**CITY OF NOVI CITY COUNCIL**  
**MAY 23, 2022**

**SUBJECT:** Approval of the request of Singh Development LLC for JSP 20-35 Townes of Main Street for approval of Preliminary Site Plan, Phasing Plan, Wetland Permit and Storm Water Management plan. The subject property is located east of Novi Road, north and south of Main Street in Section 23. The applicant proposes to develop 192 multi-family residential units on a vacant 17.69 acre site in the Town Center One District.

## Planning Review Townes at Main Street JSP 20-35

**Review Date:** March 30, 2022  
**Review Type:** Revised Preliminary Site Plan  
**Project Name:** **JSP 20-35 TOWNES AT MAIN STREET**  
 North and South of Main Street, East of Novi Road  
**Plan Date:** March 6, 2022  
**Prepared by:** Lindsay Bell, Senior Planner  
**E-mail:** lbell@cityofnovi.org; **Phone:** (248) 347-0484

Figure 1

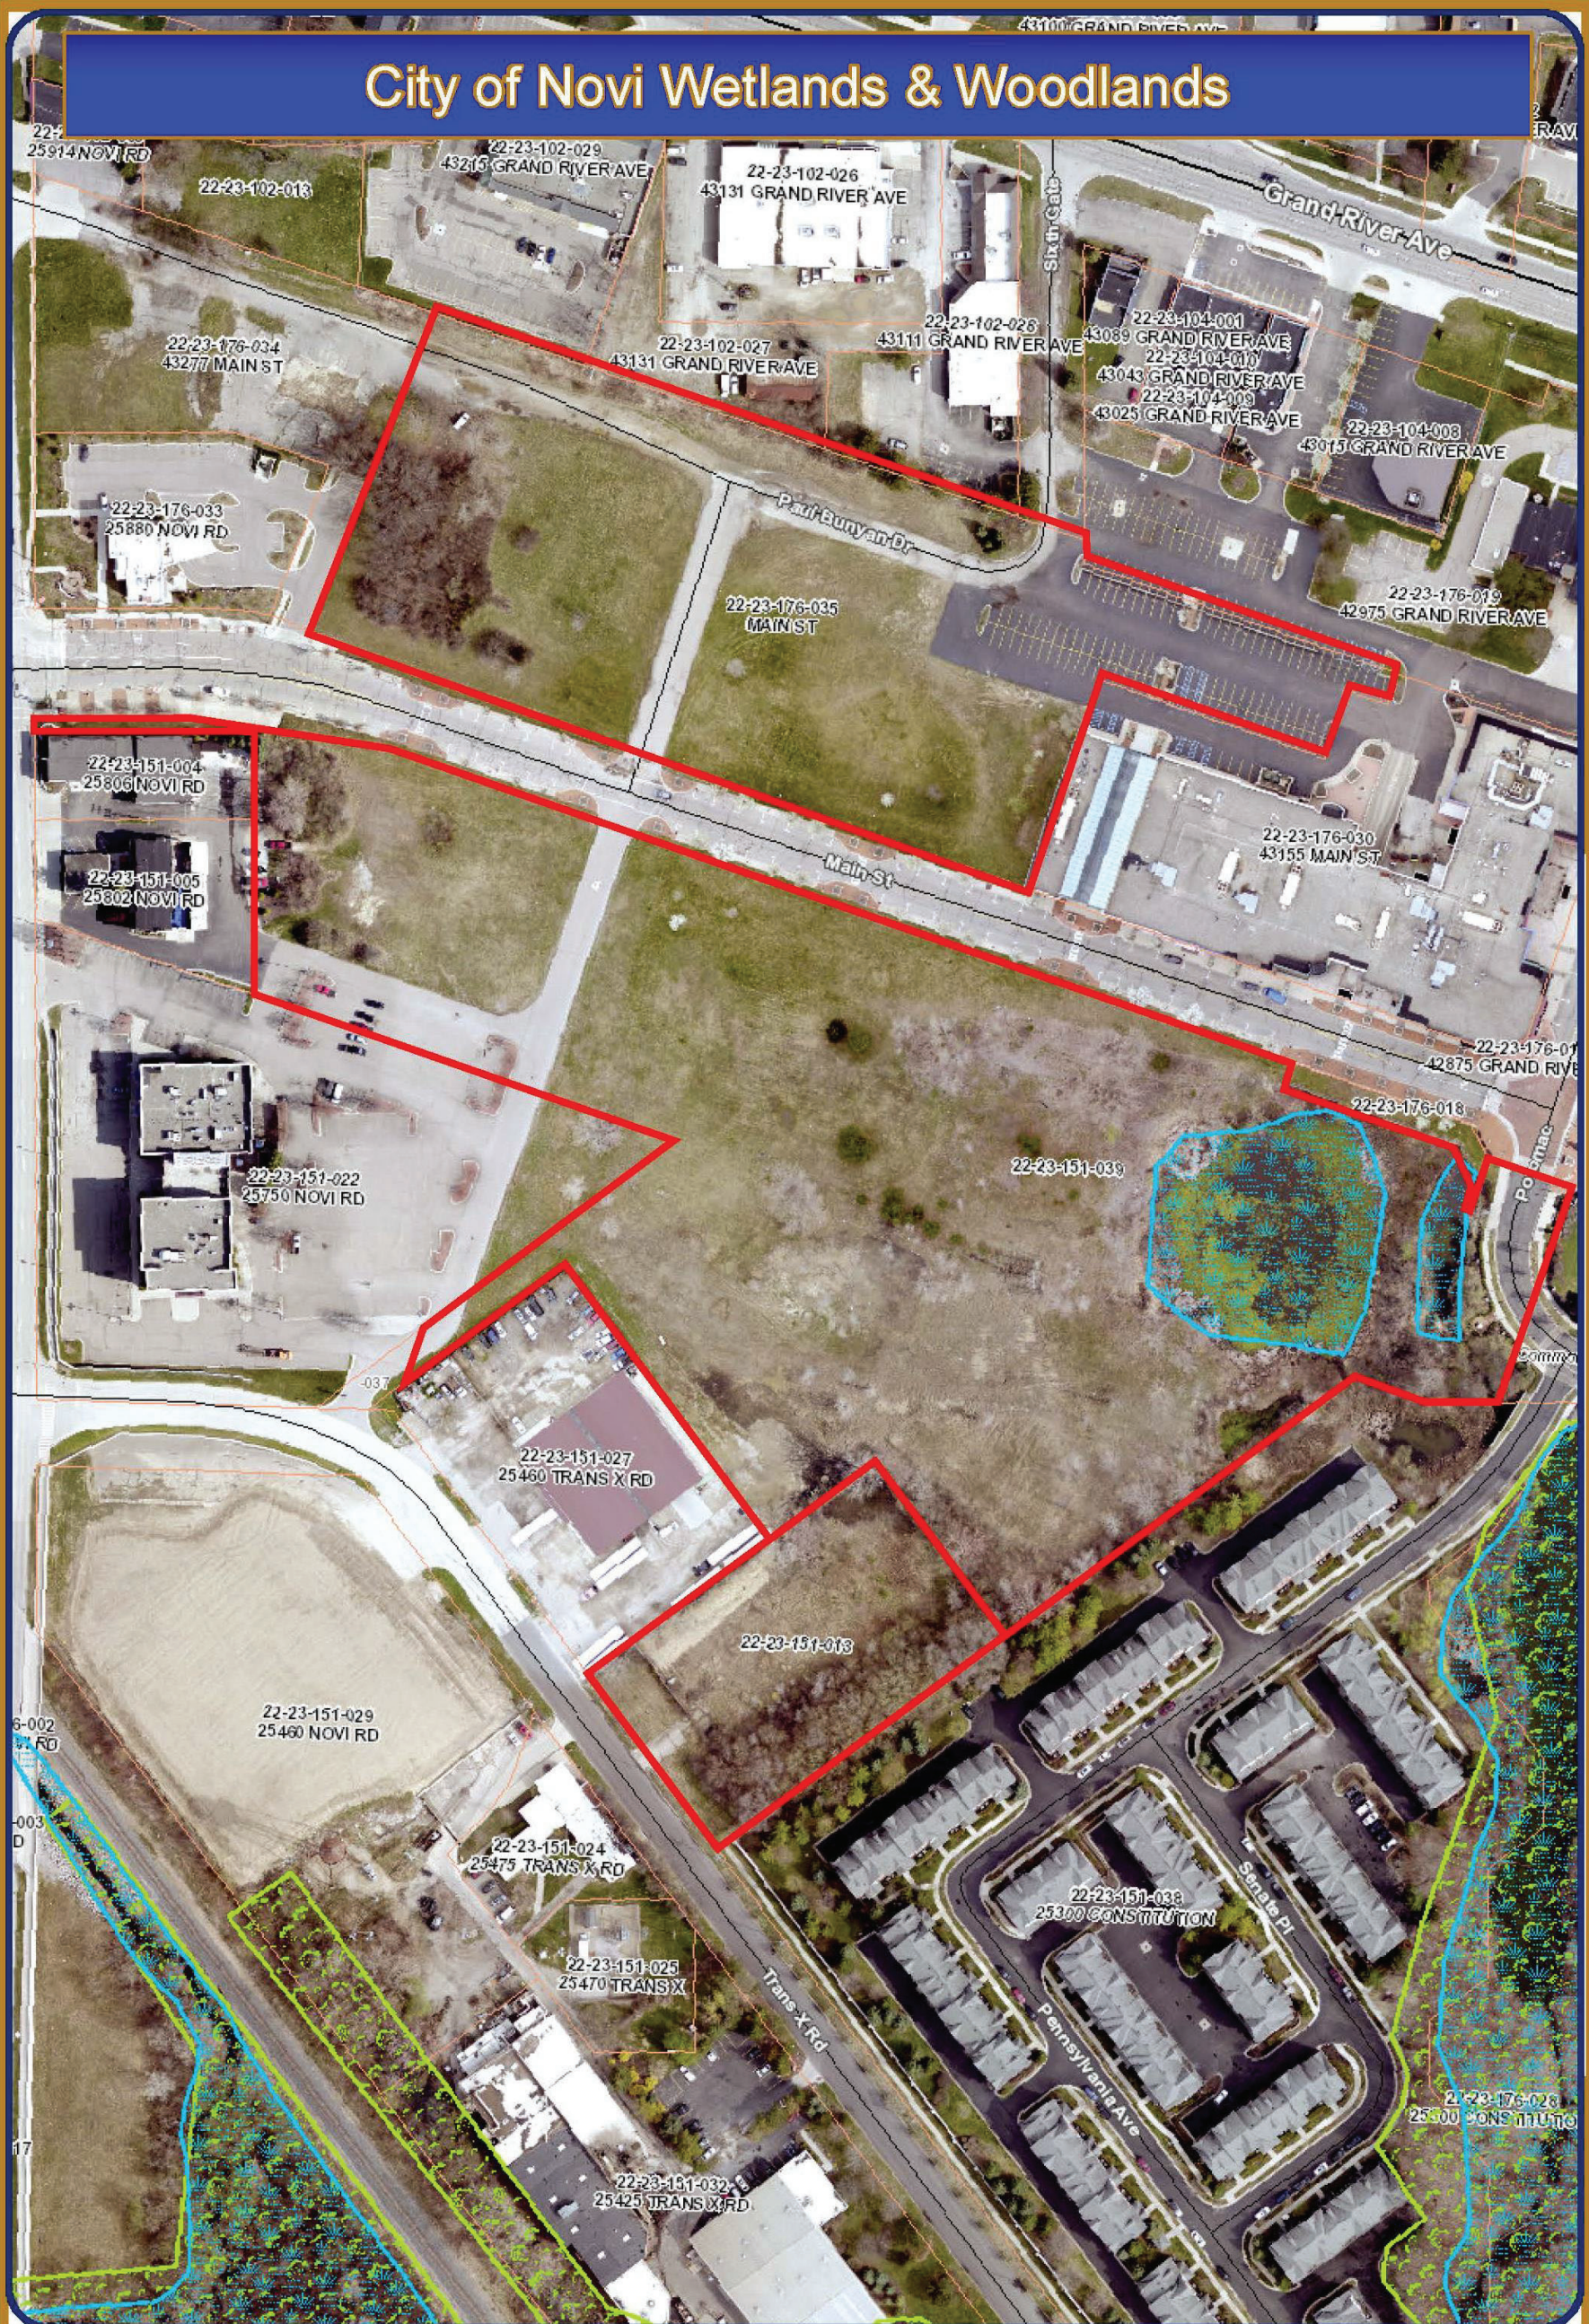
MSG reviewed The City of Novi Wetlands Maps and the Michigan Department of Environment, Great Lakes, and Energy (EGLE) Wetlands Map Viewer for the project site. The project site contains a portion of a City of Novi Regulated Wetland near the eastern-central limit of Parcel 2, where a storm water detention basin is located (Figure 1). Wetland (hydric) soils are also identified by EGLE on the Part 303 Wetlands Inventory at and around the storm water detention basin (Figure 2). Other wetland conditions are not identified by the City of Novi or EGLE at the Site.

Photo 1: View of Site Parcel 2, with the detention basin / Wetland L on the left, facing southeast.

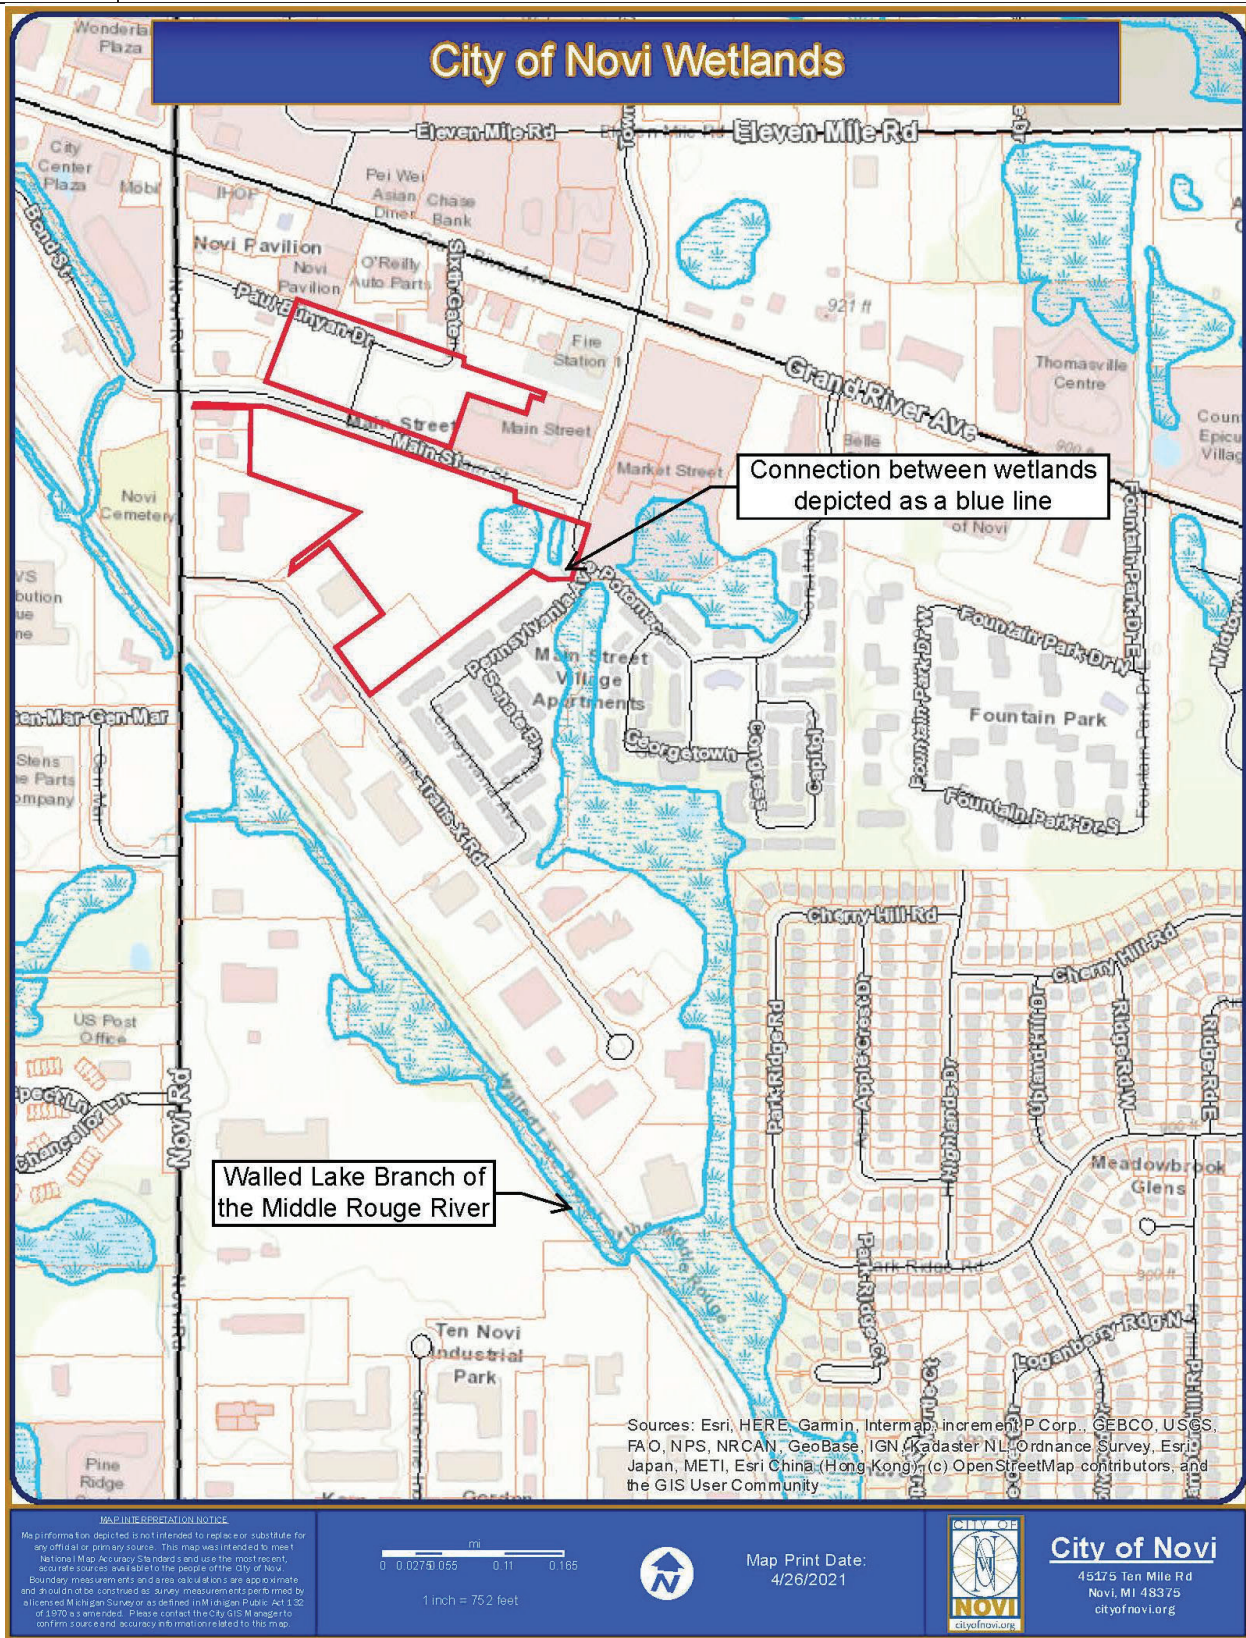
- Based on the City of Novi Wetlands Maps and the PSP, it appears the storm water detention basin (a.k.a. Wetland L) is directly connected to a tributary of the Walled Lake Branch of the Middle Rouge River (Figure 3).
- Based on MSG's review of historical aerial images of the Site, the detention basin is not a recently engineered feature. The current basin appears to be a natural formation that has been present and in communication with Walled Lake Branch of the Middle Rouge River since at least the 1940s (Figure 4).
- In addition, Wetlands M through Q are within 500 feet of the detention basin.
- Therefore, it appears likely all of the identified wetland areas would be regulated by EGLE.
